Discretionary Review Abbreviated Analysis

Date: July 31, 2014
Case No.: **2013.0791DEV**
Project Address: **135 BELGRAVE AVENUE**
Permit Application: 2013.12.12.4044
Zoning: RH-1(D) [Residential House, One-Family (Detached)]
40-X Height and Bulk District
Block/Lot: 2688/046
Project Sponsor: Jennifer Weiss
1005 Sansome Street, Suite 232
San Francisco, CA 94111
Staff Contact: Sharon Lai – (415) 575-9087
sharon.w.lai@sfgov.org
Recommendation: **Do not take DR and approve as proposed**

NORTH ELEVATION -
REVISED FOR DISCRETIONARY REVIEW (7/14/14)

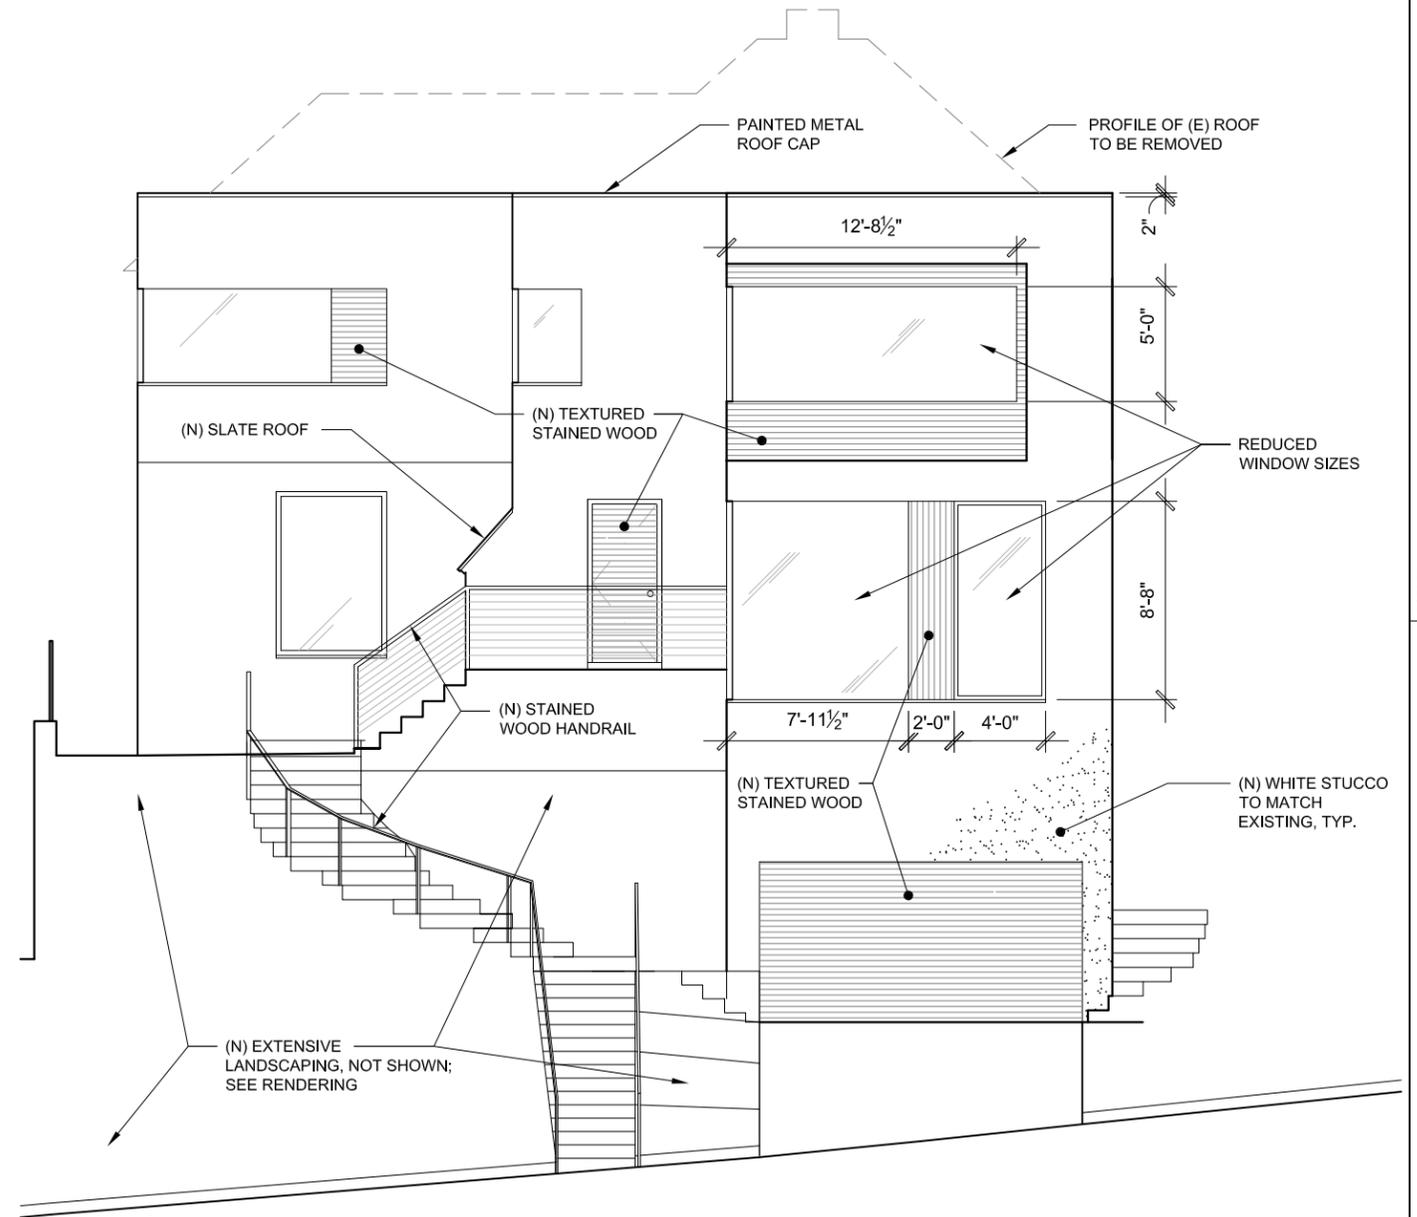
The RDT has asked us to alter our window schedule and roof treatment, and we have made these modifications as well. With these changes, we now have the RDT's support for the project.

135 NEW PROJECT

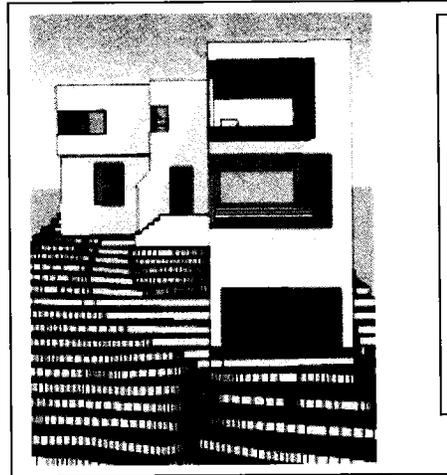
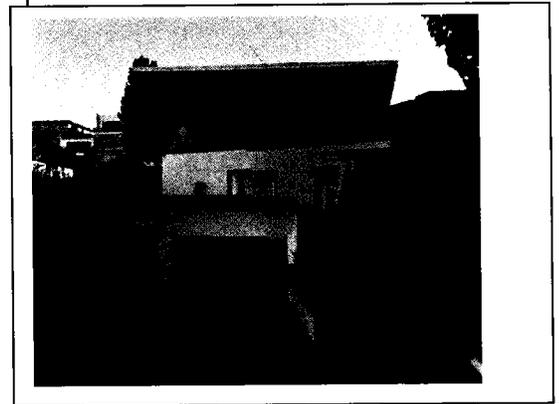
The RDG states: “Use windows that contribute to the architectural character of the building and the neighborhood” (Page 44) and “Design window features to be compatible with the building’s architectural character as well as other buildings in the neighborhood”. (Page 45) 125 Belgrave and 155 Belgrave meet this requirement. The windows on 135 NEW PROJECT design are unlike anything on Belgrave.

1 EXIST'G SITE/ROOF PLAN
A1.0 1/8"=1'-0"

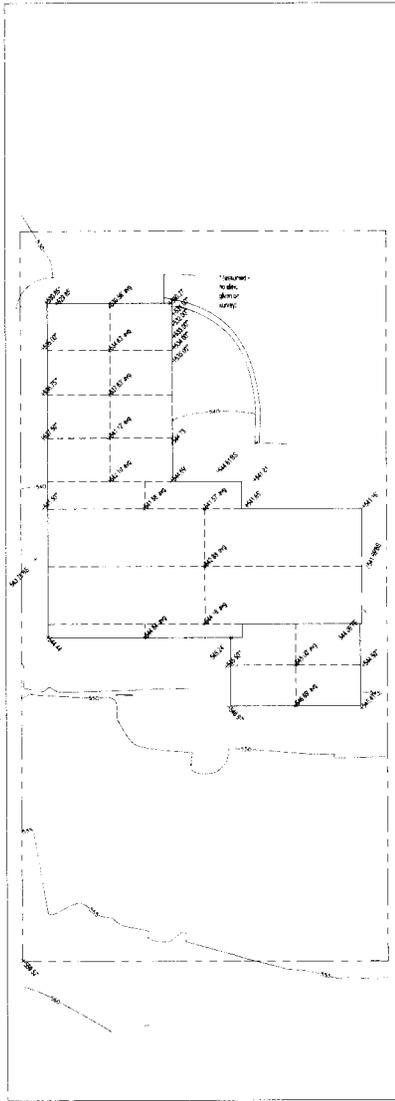
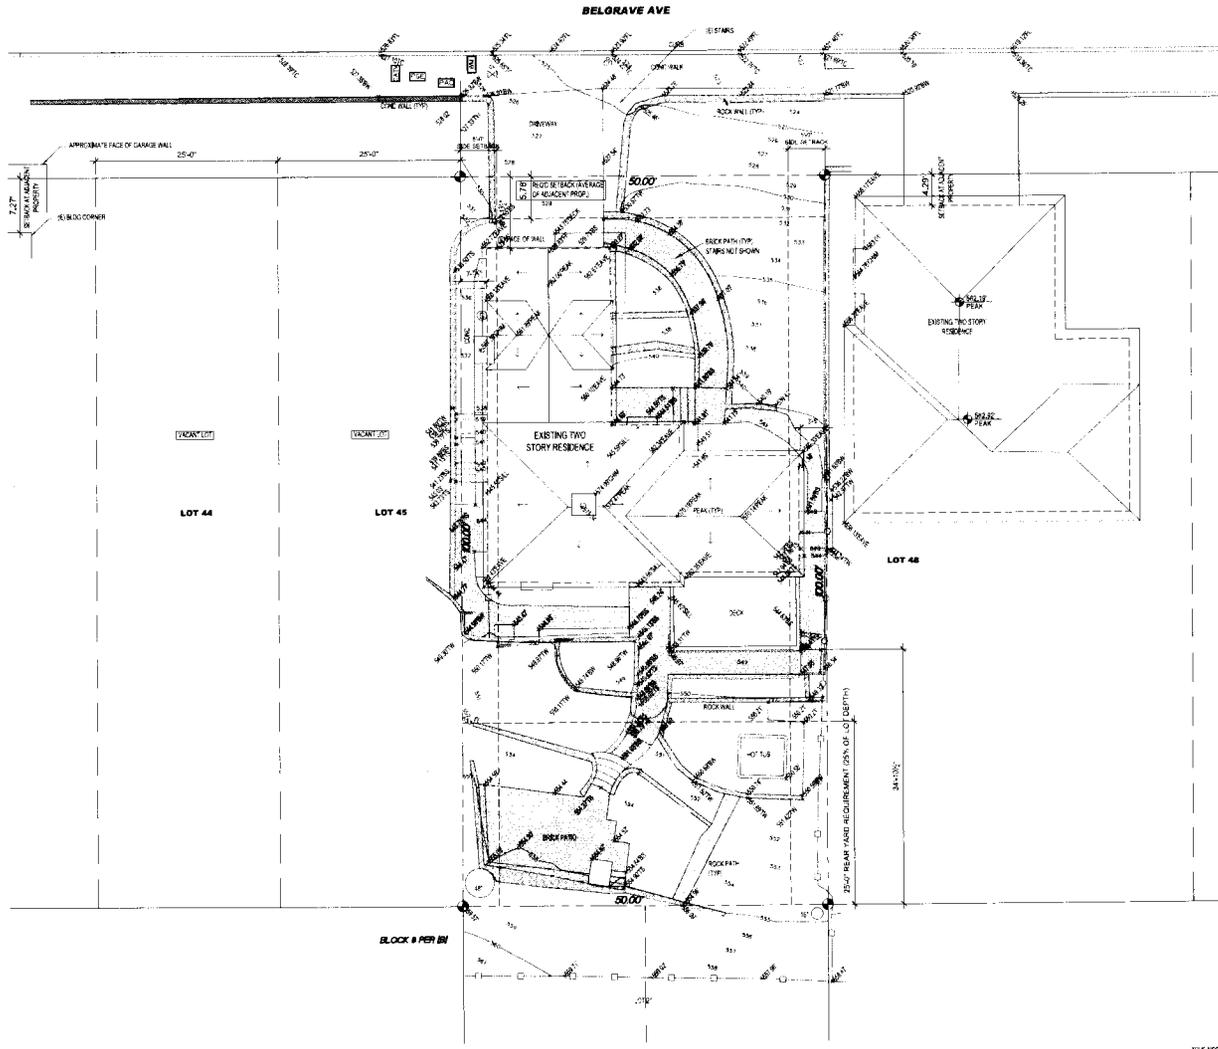
In looking at the plans, the drawings give conflicting dimensions as to just where the existing front wall of the building are in relation to the front property line. On Sheet A1.0, Existing Site/Roof & Plot Plan; Grade Calc., the setback dimension has several notes written on top of each other with the setback apparently noted as 11'-01/2". On Sheet A1.1, Proposed Site/roof & Plot Plan, no dimension at all is given. Therefore, the only reliable dimension for the distance of the front of the building wall from the front property line is that given by Meridian Surveying which is 9.9 ft.

Projecting the centerline of the existing ridge of the house extension facing the street shown on Sheet AI.0 (assumed center), the centerline coincides with a Flow Line (street elevation at the bottom of the curb) of FL 524.60 ft. To get an average top of curb (TC) elevation at this point (from which the building height can be determined), the TC/FL elevations shown west of the centerline were used. 525.65 ft. TC minus 525.34 ft. FL equal a curb height of .31 ft. So the top of curb at the centerline of the building step at the front of the property is considered to be $524.60 + .31 = 524.91$ ft. TC (I used the word "considered" since this is a driveway with no curb, only a flow line and I assumed that height measurements are taken starting at the top of what is an assumed curb in the absence of an actual one at a driveway).

1 A3.3 PROPOSED NORTH (STREET) EXT. ELEVATION WITH NEIGHBOR

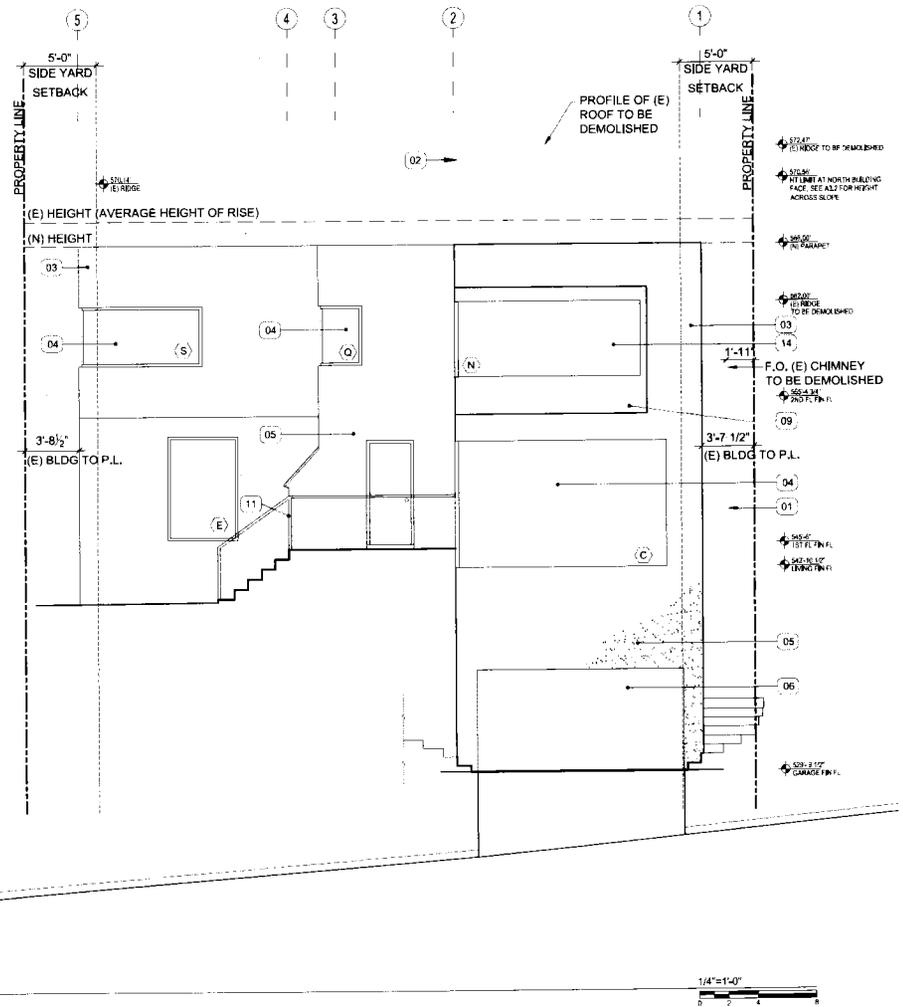
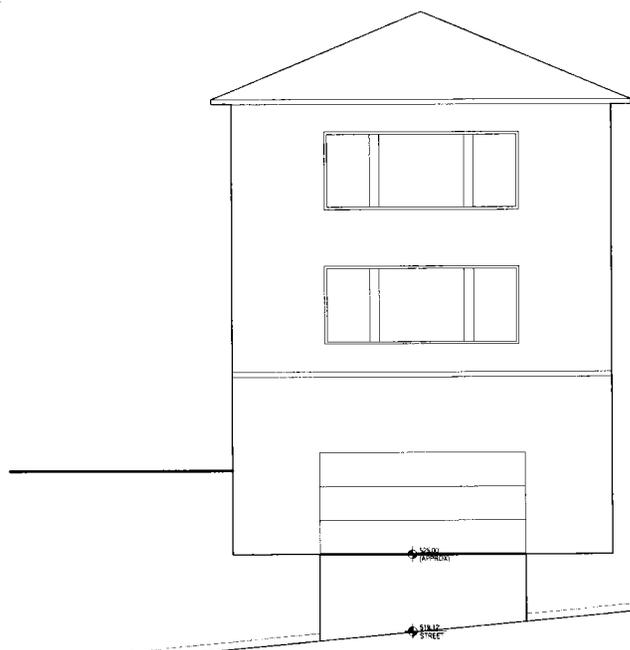
In looking at the building height, Sheet A3.3, Proposed Exterior Elevations, the new height of the building is noted as 566.00 ft. which is the new parapet. This is an incorrect height of the building since the measurement of the height of a building is defined in the SFPC Section 260 where it says:

The actual height of the proposed roof is 565.46 ft. (565 ft.-5 1/2 in.) as noted on Sheet A1.1, T.O. Roof.

UPDATED NORTH ELEVATION

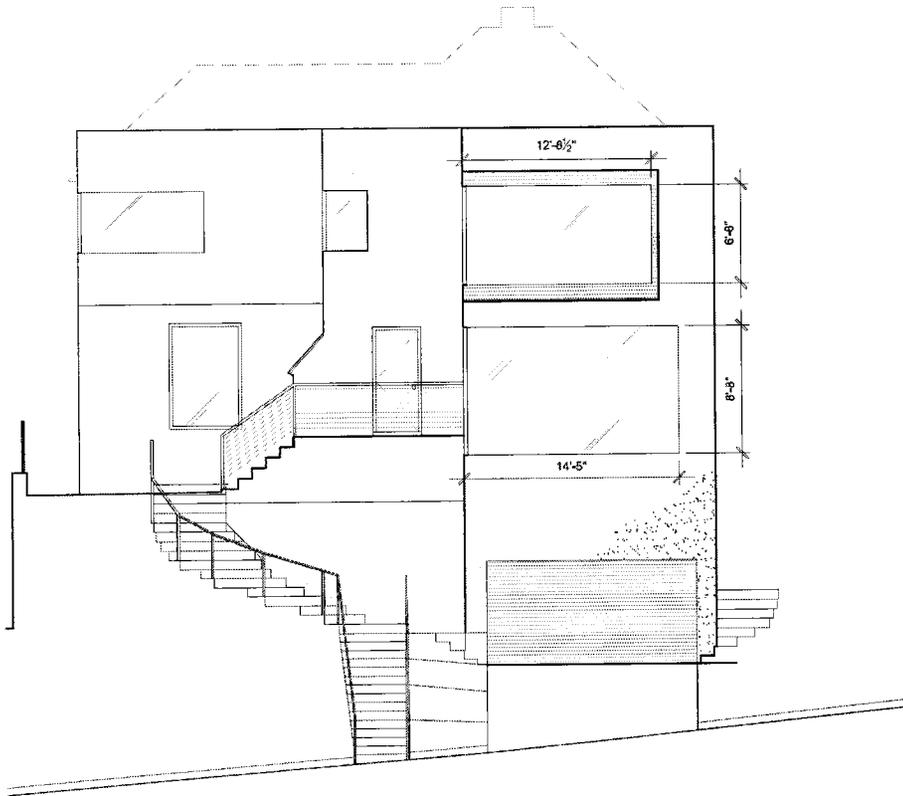
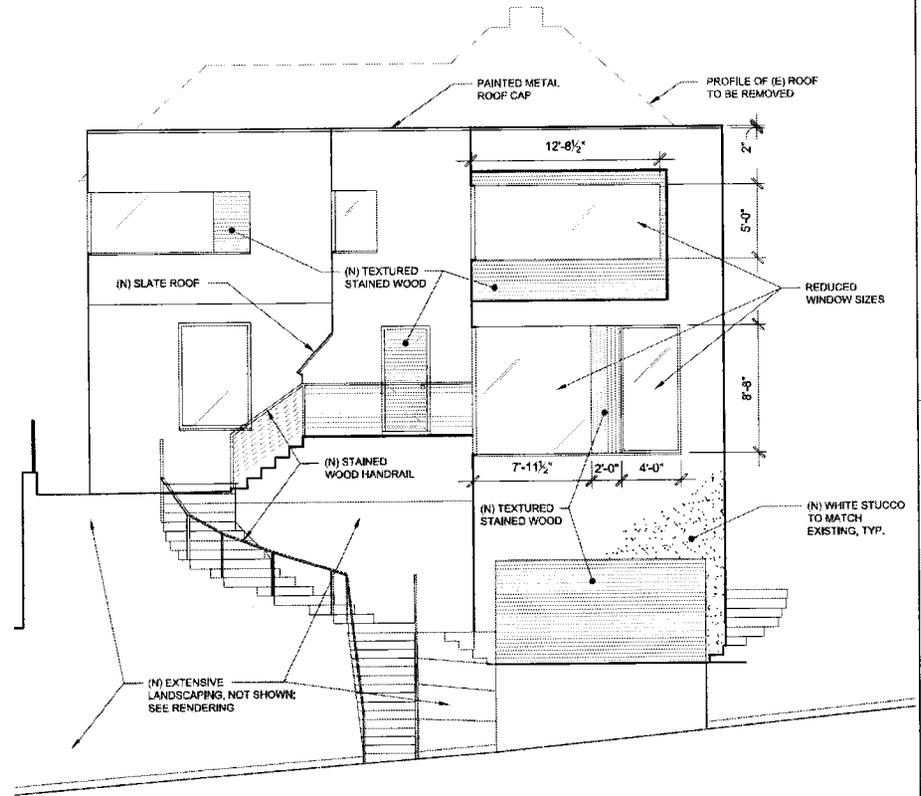
In response to the RDT notes,(which are a direct result of this DR) the project sponsors made very small adjustments in the windows in response to the RDT objections. A window that was 6 ft 8 in tall was reduced to 5 ft 2 in. One of the issues with the NEW PROJECT window design is the horizontal orientation of the windows when the orientation on Belgrave is primarily vertical. Reducing the window height without introducing any vertical elements worsened the horizontal emphasis of the NEW PROJECT window design.
